MATTER DETERMINED

PPSSWC-562 – Fairfield – DA 139.1/2025 – 72 Canley Vale Road, Canley Vale - Demolition of existing structures, site preparation works and the construction of a three (3) storey commercial building comprising: Supermarket; Commercial Premises; Food and Drink Premises; Gymnasium; and, Basement carpark and loading facilities. This application also seeks consent for the supermarket anchor tenant, signage and lot consolidation.

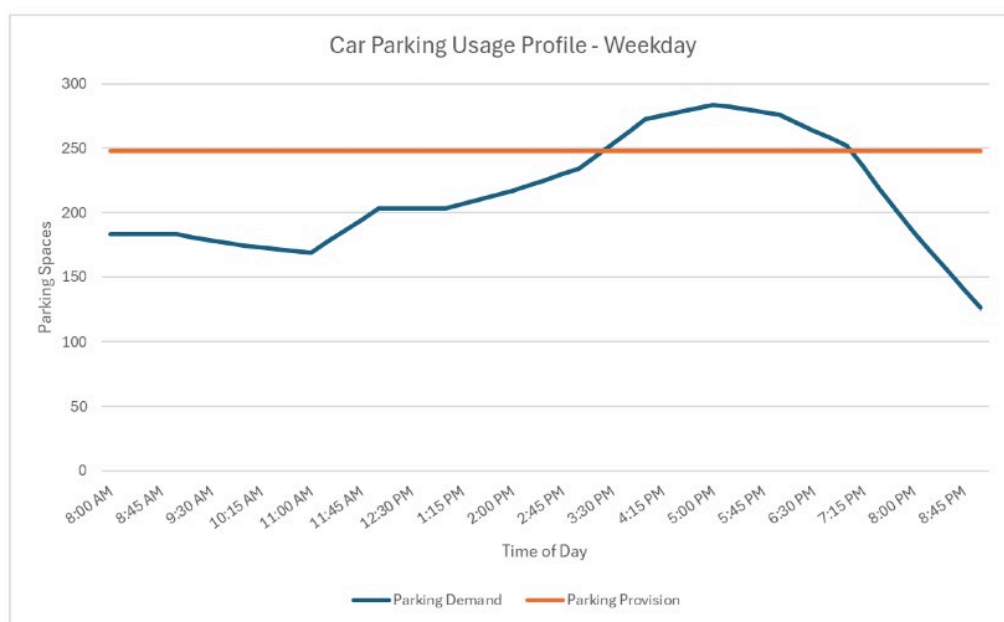
The Applicant has provided daily usage profile analysis which addresses this. For example, it assumes that the restaurant uses will operate at 0% capacity or 0% parking demand in the morning period, and at 100% at 8.00pm, while the office uses will operate at 100% in the mornings and at 0% at 8.00pm. While every use is assumed to operate at 100% for at least a part of the day, this does not occur simultaneously and therefore the full 292 spaces anticipated by the DCP are unlikely to ever be required. On the basis of these assumptions, the Applicant demonstrates that demand would only be likely to exceed supply between 3.30pm and 7.00pm on weekdays, when the number of cars required to park on the surrounding streets would fall between 1 and 33. At all other times sufficient parking would be available on site.

The Panel notes the above assessment relies on shared use of parking spaces, and that Council has provided an alternative assessment which removes office parking from the analysis on the basis that it is usually reserved and not available for public use. To address this issue, the Panel has recommended a condition of consent requiring an updated Car Park Management Plan to ensure that any parking allocated to office premises is available for public use outside of standard office hours. On this basis, the Panel is satisfied the above analysis can be relied upon.

Applying a 10% reduction to the demand shown in the above figure to account for trip sharing would result in a peak demand of 253 spaces, or a shortfall of around 5 spaces on site at around 5pm each weekday. On this basis, the demand for on-street parking would be likely to be reduced to between 1 and 5 spaces for a very short period at around 5.00pm.

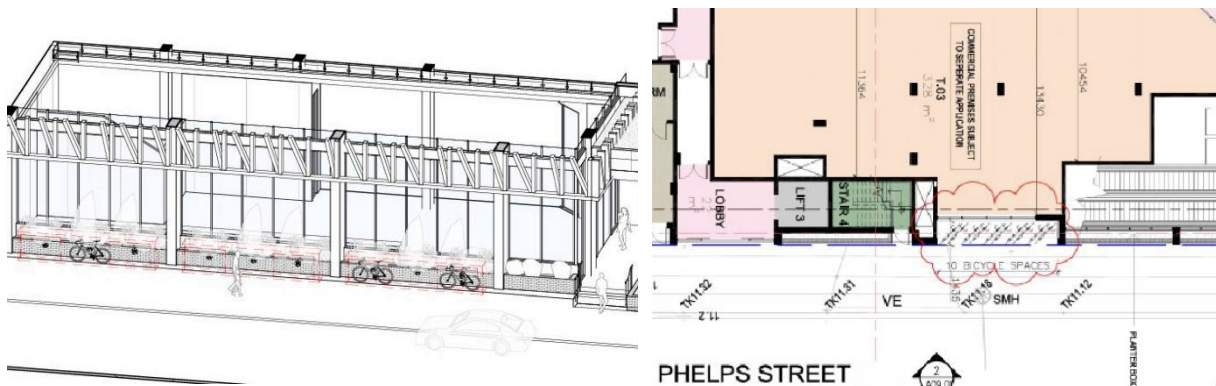
The key outstanding issue therefore relates to bicycle parking, and specifically customer parking at the ground level. The proposal makes provision for 20 bicycle parking spaces in the basement carpark and a further 9 spaces near the main shopping centre entrance at ground level. Council raised concern that the 9 spaces would result in encroachment of bicycles into the footway which could potentially conflict with pedestrian movements.

The Panel considers that provision of bicycle parking that is convenient to the front entry of the shopping centre is important for encouraging non-car forms of travel, particularly as the proposal will result in a small shortfall of parking supply in the early evenings as discussed above. The Panel also agrees with Council that this parking should be provided on-site and designed so as not to interfere with the pedestrian footpath.

The Applicant has identified two solutions that have the potential to meet these requirements within the site adjacent to the Phelps Street boundary as shown in the following two images. The Panel considers that either solution would be appropriate, subject to detailed design to demonstrate the 9 spaces can be provided without encroachment of parked bicycles into the footpath. A condition is recommended requiring updated plans to this effect as detailed below.

~~Prior to the issue of a Construction Certificate, amended architectural plans shall be submitted to and approved by the certifier, demonstrating the provision of nine (9) ground level bicycle car parking spaces in accordance with AS2890.3 that:~~
